The City of Lake Forest Building Review Board Agenda

Wednesday, December 2, 2020

4. Consideration of a request for approval of a new residence on a vacant lot, a conceptual landscape plan, and overall site plan. The property is addressed as 1400 Oak Knoll Drive. This property is one of three new lots created by the Estate Lane Subdivision.

5. Consideration of a request for approval of the partial demolition of the existing residence and construction of a two-story rear addition including an increase in the height of the roof and extension of the north wall at **2 June Terrace**. An elongated, detached garage is also proposed.

PRELIMINARY LANDSCAPE PLAN

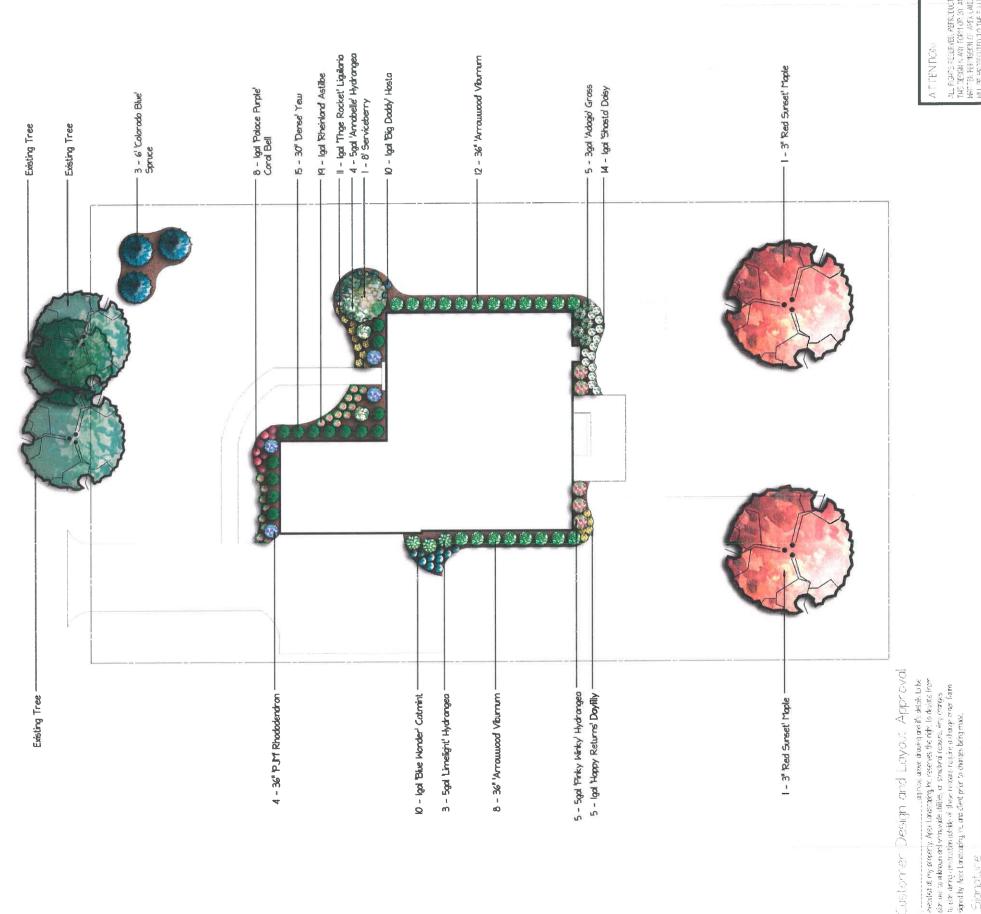
Based on the preliminary landscape plan, the total number of replacement inches is not yet satisfied. In addition to the required replacement inches, the Code establishes a minimum criteria for

landscaping for new residential construction. As currently proposed, the minimum criteria for landscaping is not fully satisfied and additional shade trees and understory or evergreen plantings are needed to meet the minimum landscape requirements for new residences. As the landscape plan is further developed it will need to be further detailed with additional plantings and will be subject to review and approval by the City.

- 5. A complete and accurate tree survey for the property shall be submitted with the plans submitted for permit.
- 6. The final landscape shall include, but not be limited to, all required replacement tree inches to account for trees removed, plantings along the west property line to screen the garage doors and garage apron, and trees in the front yard to soften the appearance of the house from the streetscape over time.

SITE PLAN AR 01

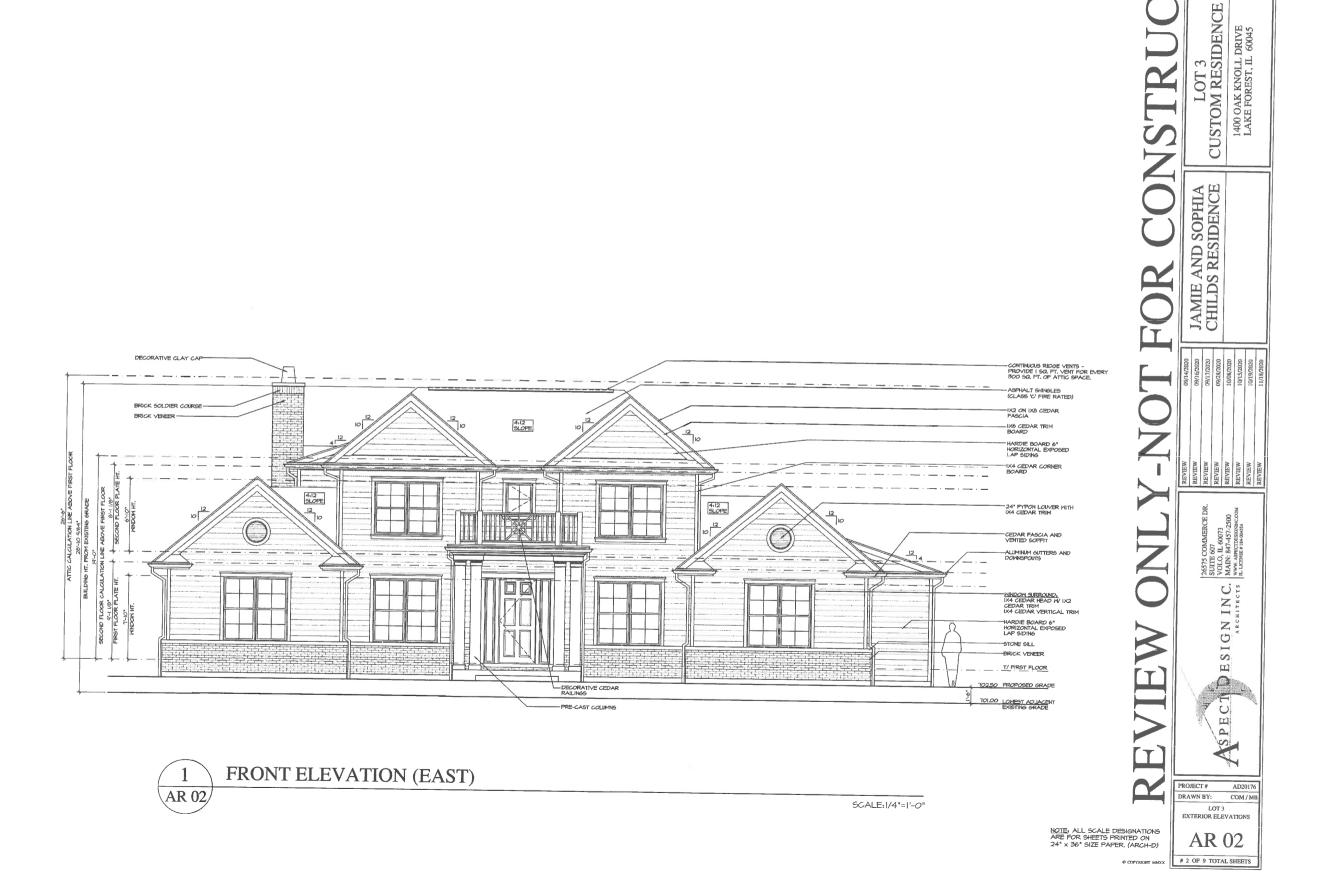
The proposed residence faces east, toward Oak Knoll Drive, with the attached side-load garage facing north. The garage court is proposed very close to the north property line. The location of the garage court as currently proposed does not allow any space for plantings to provide screening of the driveway and garage doors from the adjacent lot. The proximity of the driveway apron to the property line is the result of the width and configuration of the proposed house. In this case, the house extends right up to the setback line on the south side of the property leaving no room for adjustment. It would be unusual for the Board to approve a new home with not screening of side yard facing garage doors and the driveway apron.

- a. Further study of the site plan as it relates to the size and placement of the driveway should be conducted in an effort to locate the driveway in a manner that provides for screening of the neighboring property. Alternatively, if the developer acquires the neighboring property, a landscape buffer covenant determined to be acceptable by the City may be recorded on the adjacent property, Lot 2 of the Estate Lane Subdivision, to assure an ongoing buffer between the properties.
